January 4, 2002

Docket No. 50-321

HL-6163

Edwin I. Hatch Nuclear Plant - Unit 1
Request to Revise Technical Specifications:
Safety Limit Minimum Critical Power Ratios (SLMCPR)

Figure 1
Reference Core Loading Pattern – Cycle 20

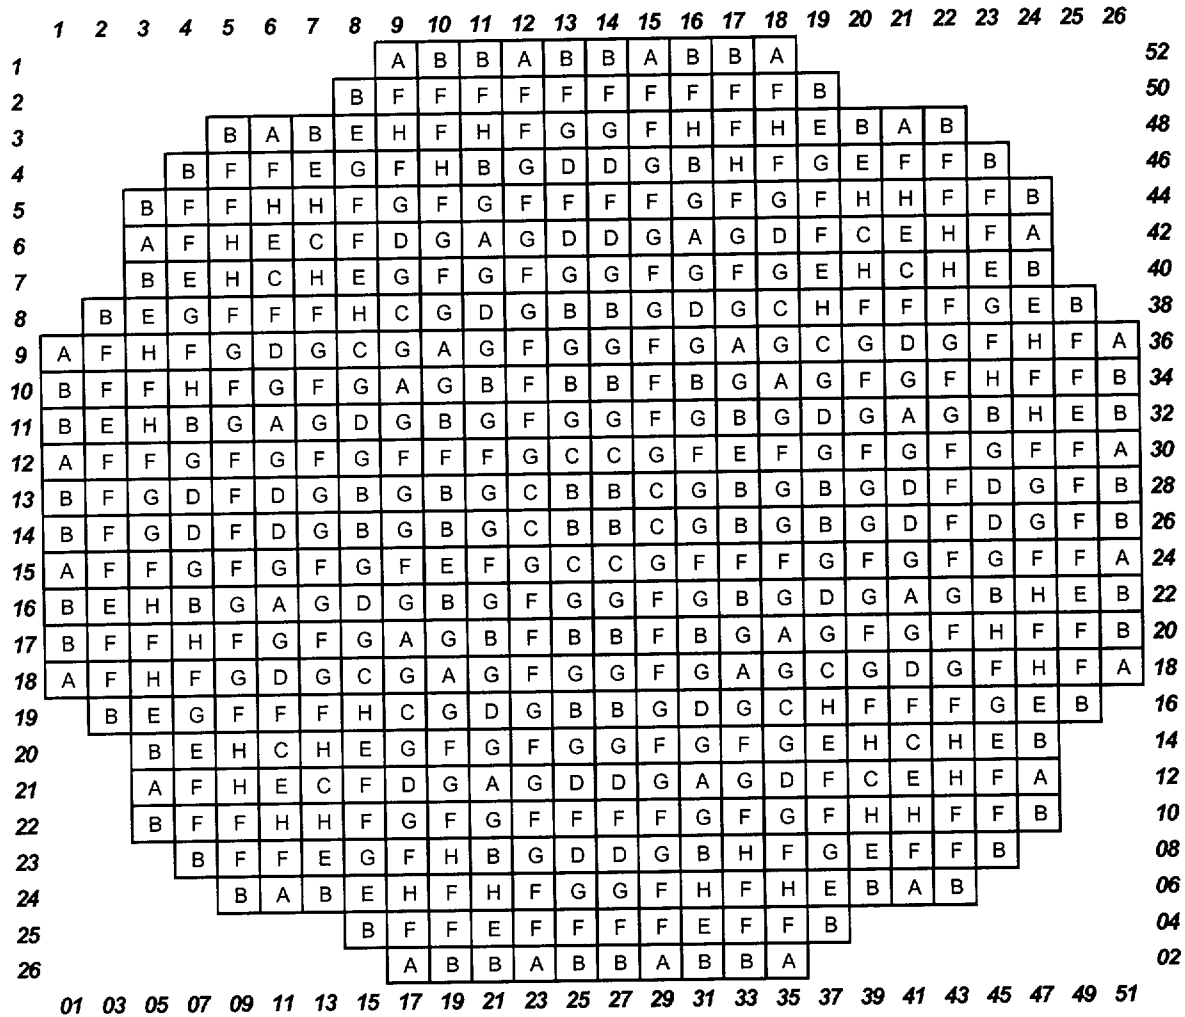
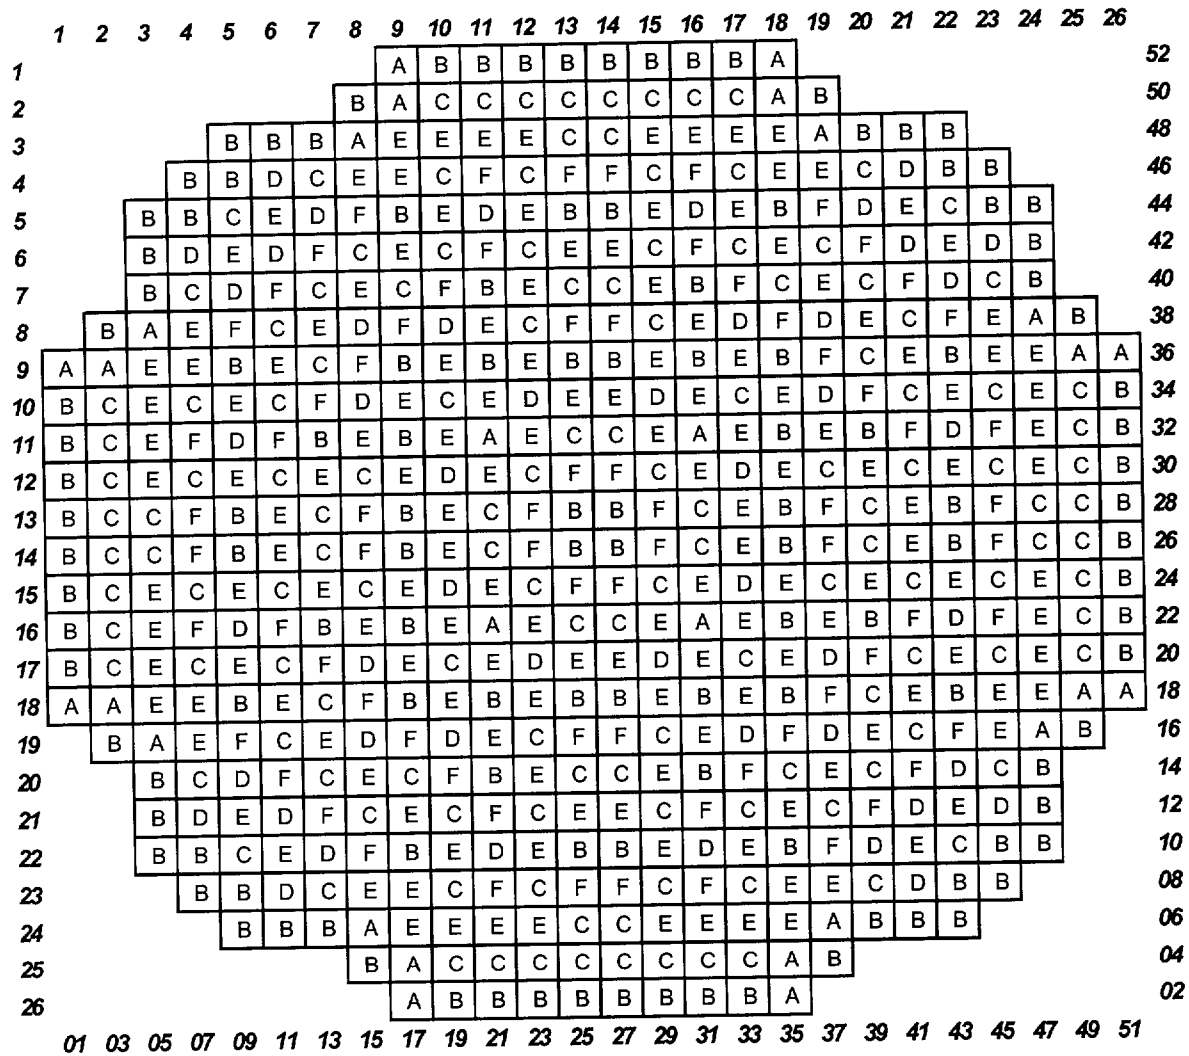
The core loading information for Hatch Unit 1 Cycles 20 and 21 is provided in Figures 1 and 2, respectively. The impact of the fuel loading pattern differences on the calculated SLMCPR is correlated to the values of [[]].
